REVISIONS TO THE SCDOT SEISMIC DESIGN SPECIFICATIONS FOR HIGHWAY BRIDGES

January 2025

The revisions included herein shall apply to the SCDOT Seismic Design Specification for Highway Bridges and they supersede Bridge Design Memorandum DM0115.

Figure 6.2 Typical and Oversized Drilled Shafts

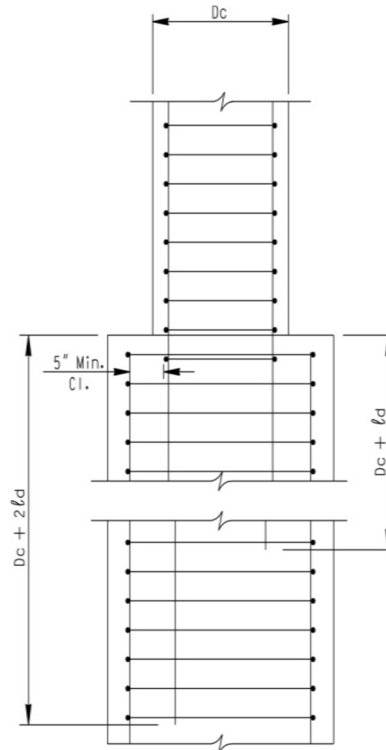
Delete the elevation view of the Oversized Drilled Shaft in the figure and replace it with the following:

ℓ_d = development length

Figure 6.2 Oversized Drilled Shaft

Figure 8.2 Transverse Reinforcement for Column on Non-oversized Drilled Shaft

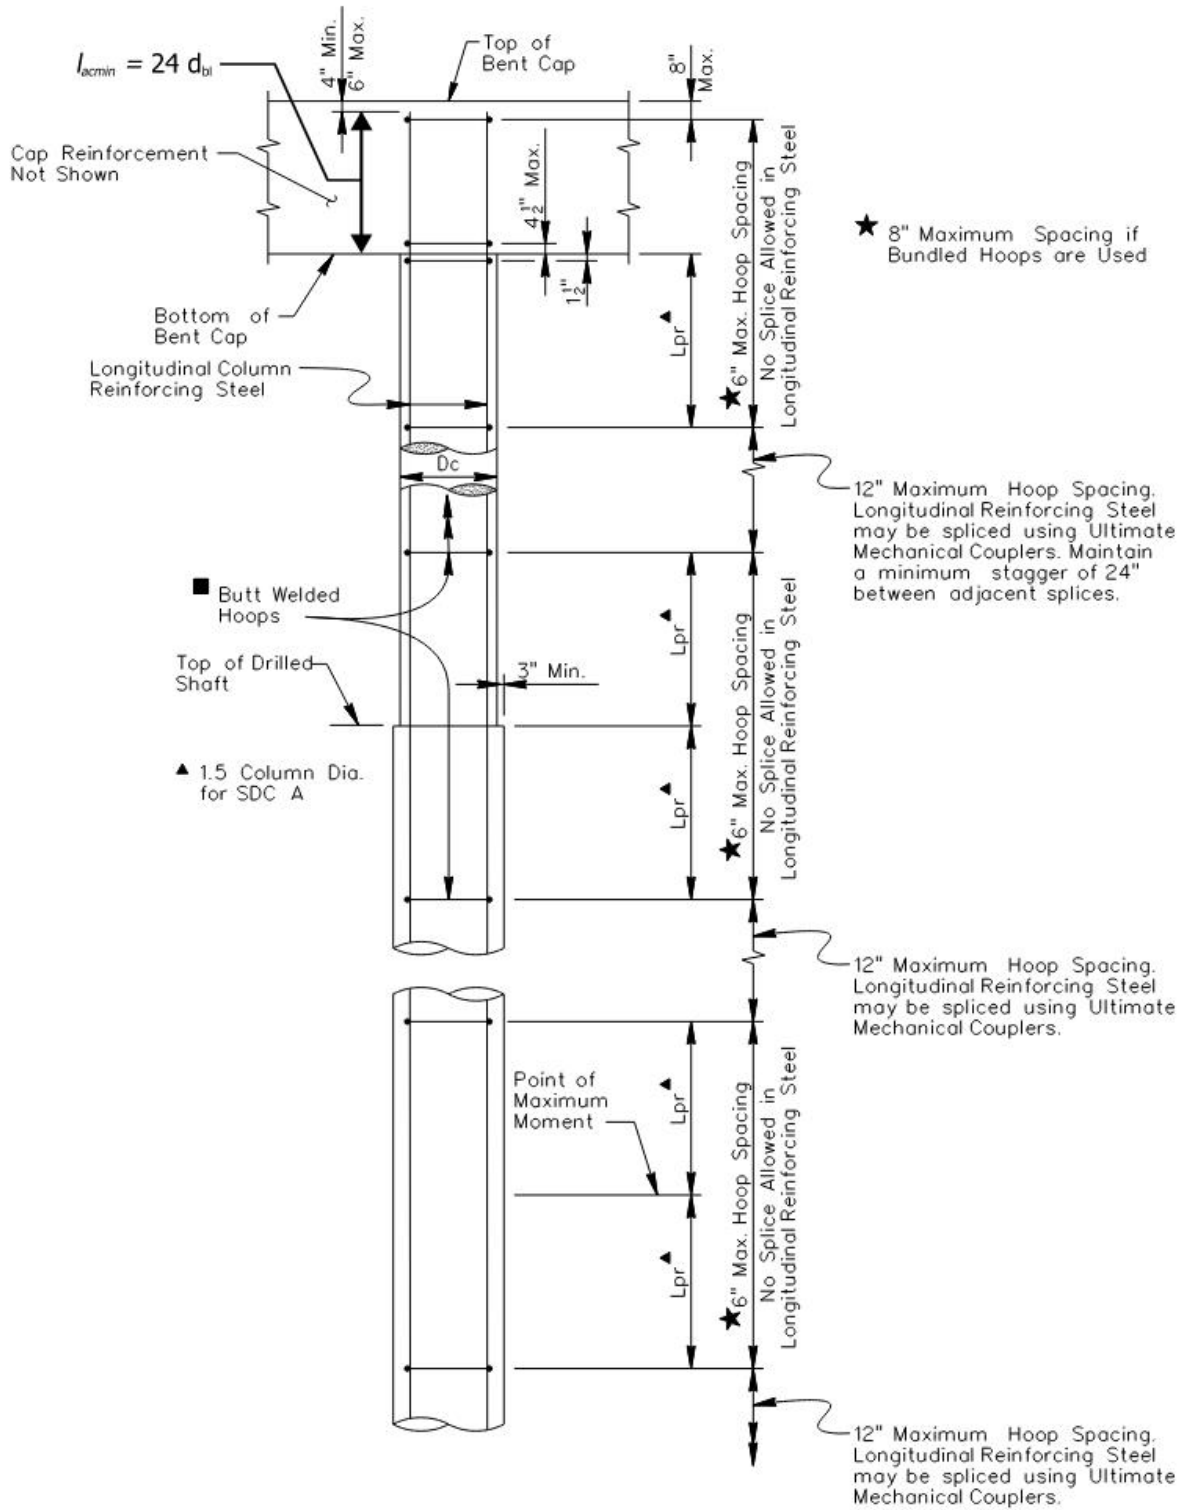
Delete the figure and replace it with the following:

■ Hoops shall have butt welded splices. The minimum size shall be #19 (#6) and the maximum size shall be #25 (#8). To prevent the hoop weld splices from being located on the same vertical plane, the locations of the splices shall be staggered around the perimeter of the column by a minimum distance of 1/3 of the hoop circumference.

Figure 8.2 Transverse Reinforcement for Column on a Non-oversized Drilled Shaft

Figure 8.3 Transverse Reinforcement for Column on a Pile Footing

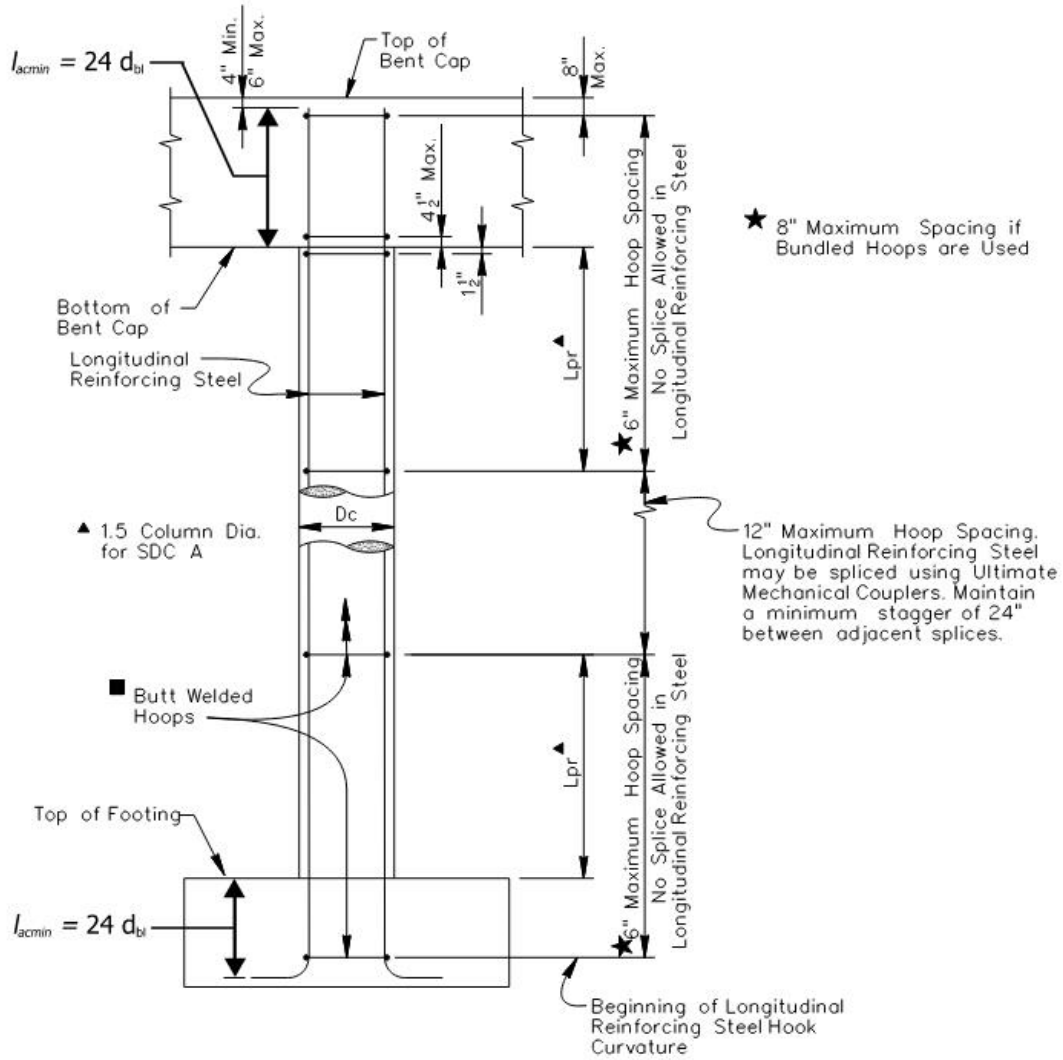
Delete the figure and replace it with the following:

- Hoops shall have butt welded splices. The minimum size shall be #19 (#6) and the maximum size shall be #25 (#8). To prevent the hoop weld splices from being located on the same vertical plane, the locations of the splices shall be staggered around the perimeter of the column by a minimum distance of 1/3 of the hoop circumference.

Figure 8.3 Transverse Reinforcement for a Column on a Pile Footing

Figure 8.4 Transverse Reinforcement for Column on an Oversized Drilled Shaft

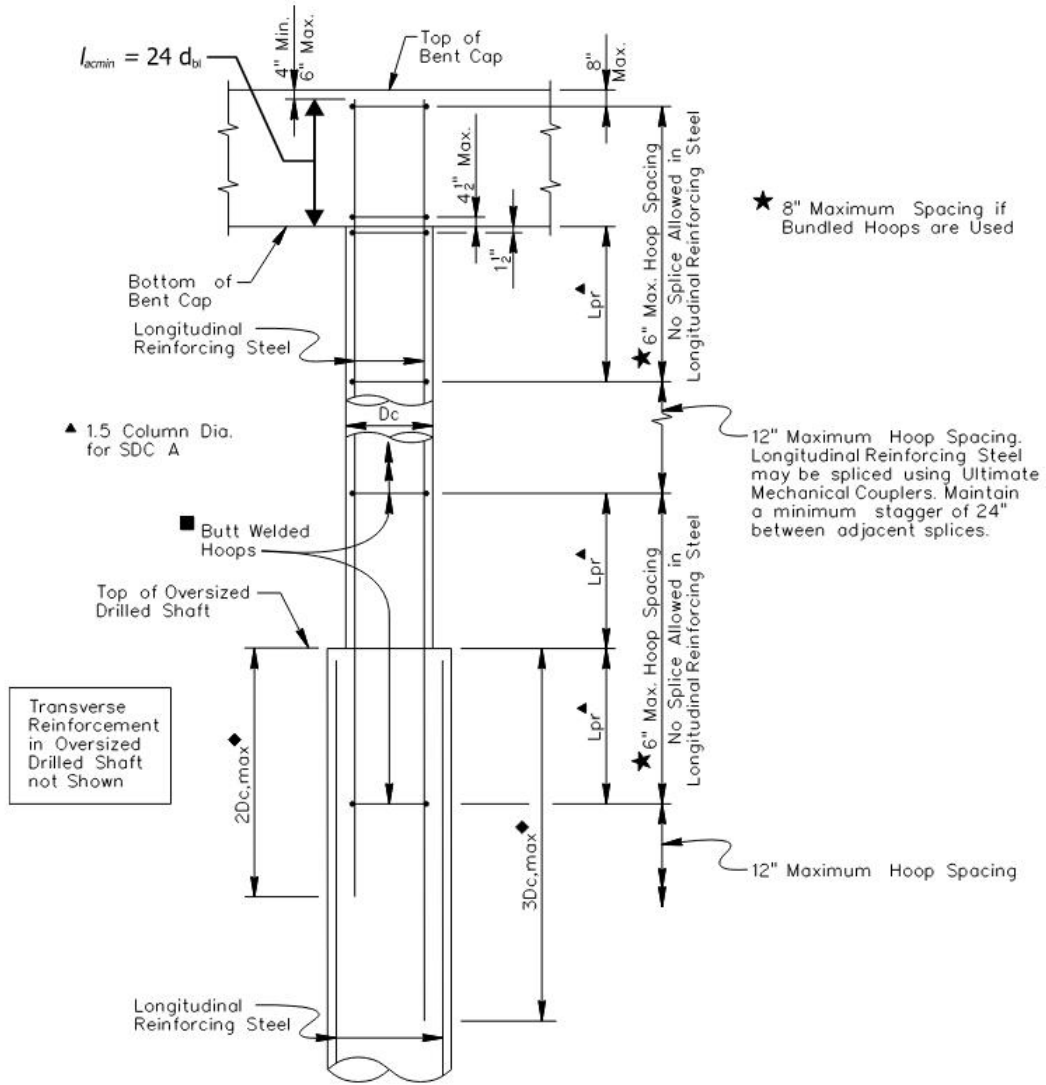
Delete the figure and replace it with the following:

◆ $D_{c,max}$ is the largest cross sectional dimension of the column.

■ Hoops shall have butt welded splices. The minimum size shall be #19 (#6) and the maximum size shall be #25 (#8). To prevent the hoop weld splices from being located on the same vertical plane, the locations of the splices shall be staggered around the perimeter of the column by a minimum distance of 1/3 of the hoop circumference.

Figure 8.4 Reinforcement for Column on Oversized Drilled Shaft

Note: Shaft transverse reinforcement does not have the same diameter as the column transverse reinforcement

Figure 9.2 Concrete Superstructure Shear Key

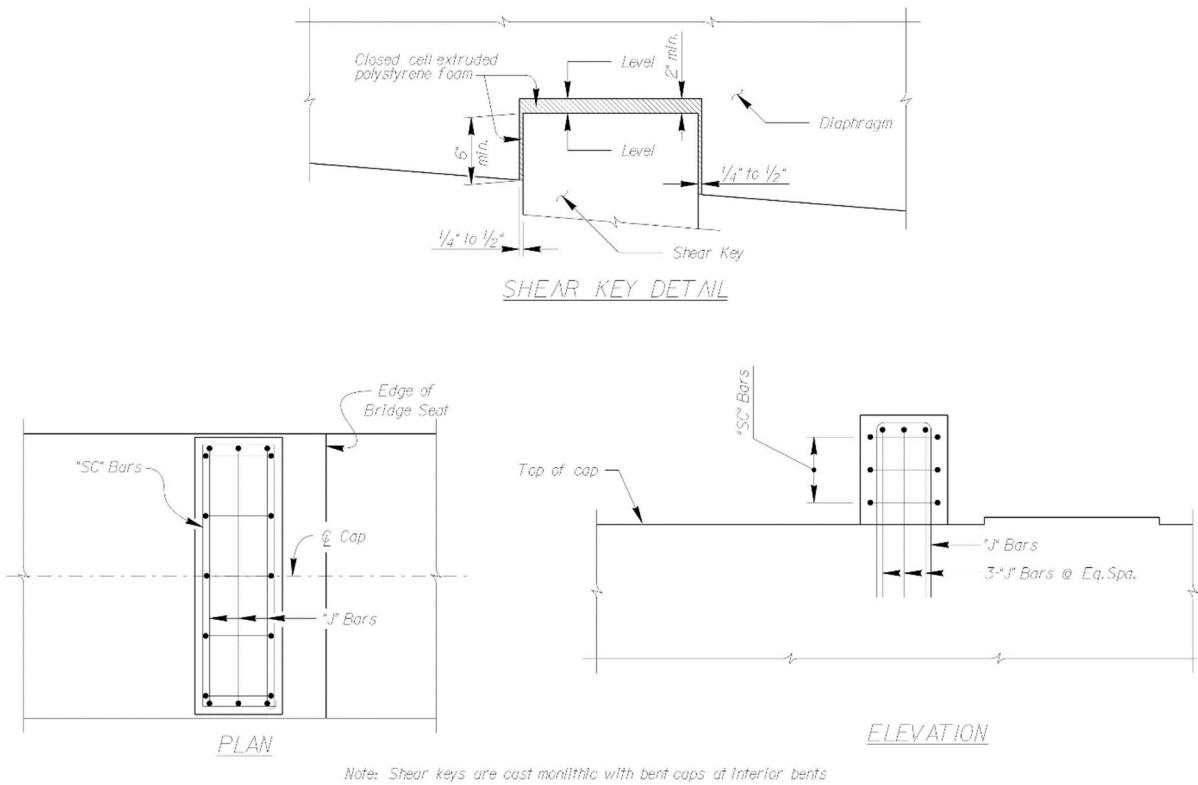
Delete Figure 9.2 and replace with the following:

Figure 9.2 Concrete Superstructure Shear Key
